ECLIPSE  
AEROSPACE

## SERVICE BULLETIN

**NUMBER:** SB 500-21-004, REV C  
**MODEL:** ECLIPSE EA500  
**SUBJECT:** VORE SEAL INSTALLATION

**VORE Butterfly Gap Measurement  
Figure 1**

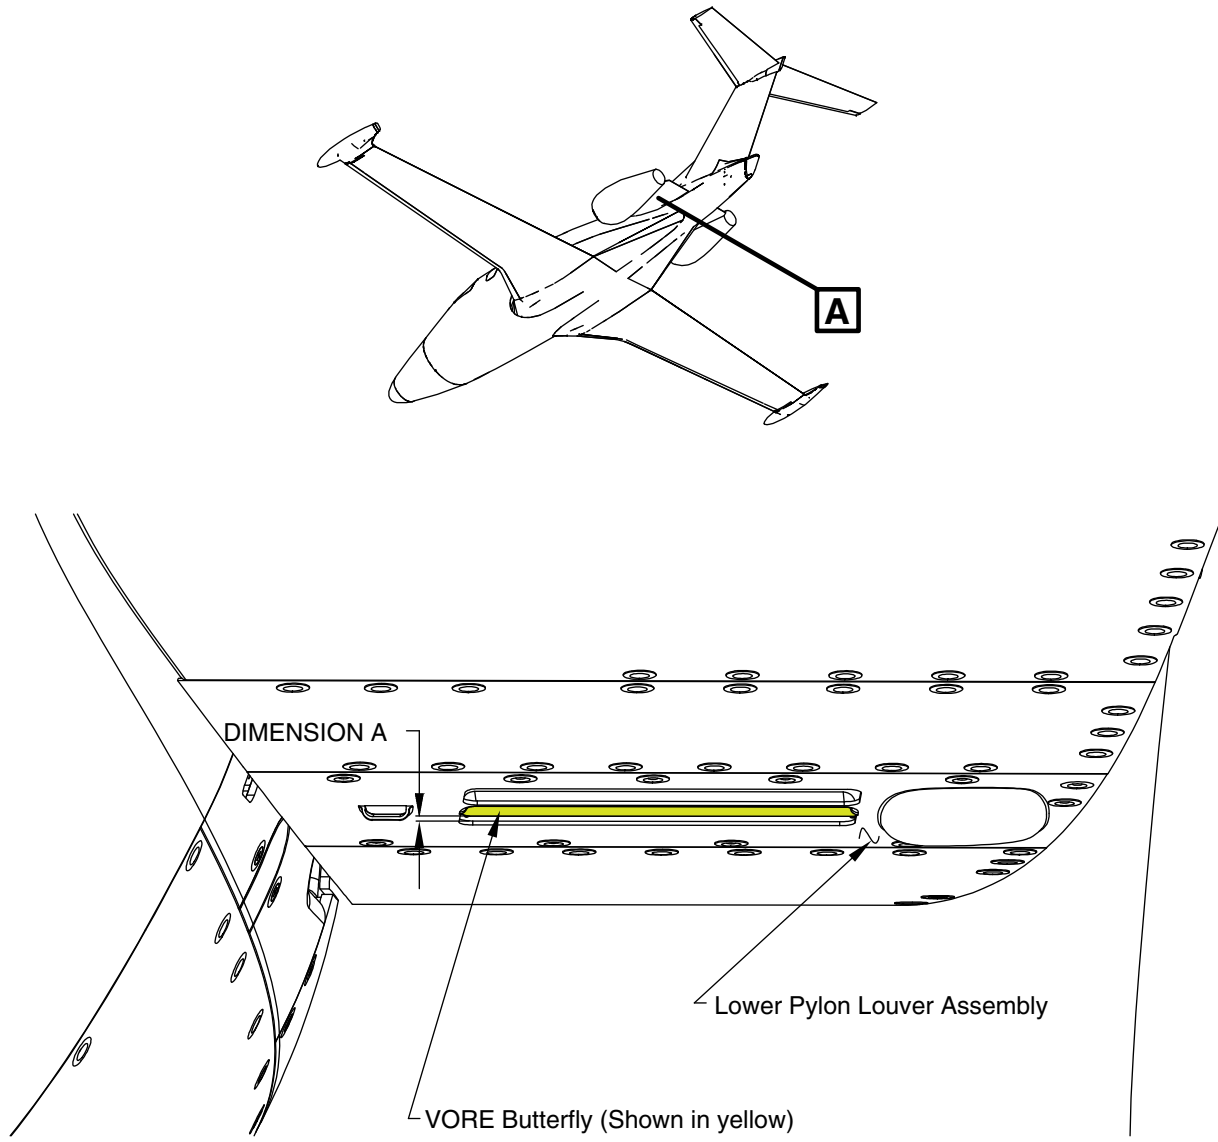
Revision C changes: Added VORE Butterfly/panel gap measurement and DSP0018-250 (white) or DSP0048-250 (Gray) for VORE Butterfly/panel gaps greater than 0.125 inch.

- (a) Make the aircraft safe for maintenance. Refer to AMM - 20-00-01 - MAKE SAFE FOR MAINTENANCE. \_\_\_\_\_
- (b) Measure gap distance at the widest point between Left VORE Butterfly and interior of Left Lower Pylon Louver Assembly - 311 KL. If Dimension A is greater than 0.125 inch use DSP0018-250 (0.25 inch thickness) or DSP0048-250 (0.25 inch thickness), otherwise use DSP0018-125 (0.125 inch thickness) or DSP0048-125 (0.25 inch thickness). Refer to [Figure 1](#). \_\_\_\_\_
- (c) Measure gap distance at the widest point between Right VORE Butterfly and interior of Right Lower Pylon Louver Assembly - 312 GR. If Dimension A is greater than 0.125 inch use DSP0018-250 (0.25 inch thickness) or DSP0048-250 (0.25 inch thickness), otherwise use DSP0018-125 (0.125 inch thickness) or DSP0048-125 (0.25 inch thickness). Refer to [Figure 1](#). \_\_\_\_\_

NOTE: If Dimension A (Figure 1) is greater than .125 inch use DSP0018-250 (white) or DSP0048-250 (Gray).

**Lower Pylon Louver Assembly, Left Side Shown, Right Side Opposite  
Figure 2**

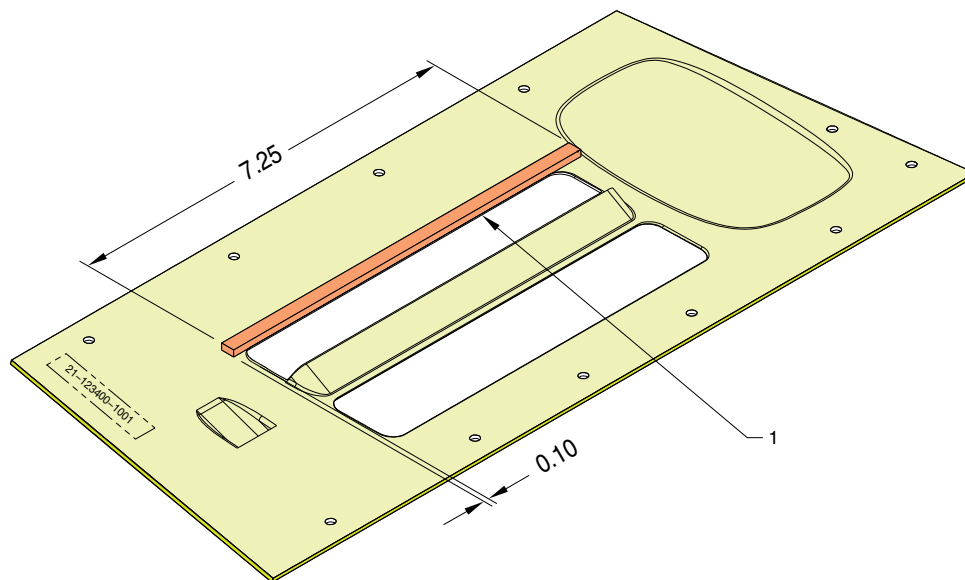
- (a) Clean area where Silicone Foam - Open Cell is to be applied with Isopropyl Alcohol/Water (50/50 mix). Allow to dry. \_\_\_\_\_
- (b) Apply a 7.25 inch strip of Silicone Foam - Open Cell P/N DSP0018-125 (white) or DSP0048-125 (Gray) (1, Figure 2) with RTV 106 Adhesive to Left Lower Pylon Louver Assembly - 311 KL and Right Lower Pylon Louver Assembly - 312 GR flush with opening. Allow RTV time to cure per manufacturer's instructions. \_\_\_\_\_

NOTE: If Dimension A (Figure 1) is greater than .125 inch use DSP0018-250 (white) or DSP0048-250 (Gray).

- (c) Part mark left and right assemblies 21-123400-1001 with indelible ink in area shown. Refer to Figure 2. \_\_\_\_\_

**VORE Rework  
Figure 3**

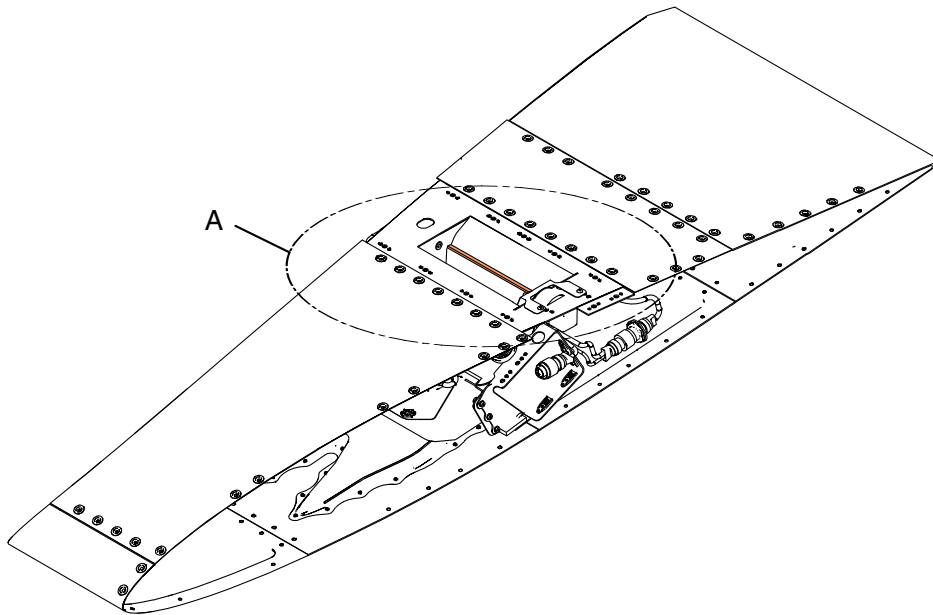
Revision B changes: Corrected typo for tolerance in Adjustment/Test. Was: 0.98 Is: .098. Revised Figure 3 for clarity of foam installation.

- (a) Clean area where Silicone Foam - Open Cell is to be applied with Isopropyl Alcohol/Water (50/50 mix). Allow to dry.
- (b) Apply a 7.06 inch strip of Silicone Foam - Open Cell P/N DSP0018-125 (white) or DSP0048-125 (Gray) (1, Figure 3) with RTV 106 Adhesive to ledge in the Left and Right BASS Assemblies. Allow RTV time to cure per manufacturer's instructions.
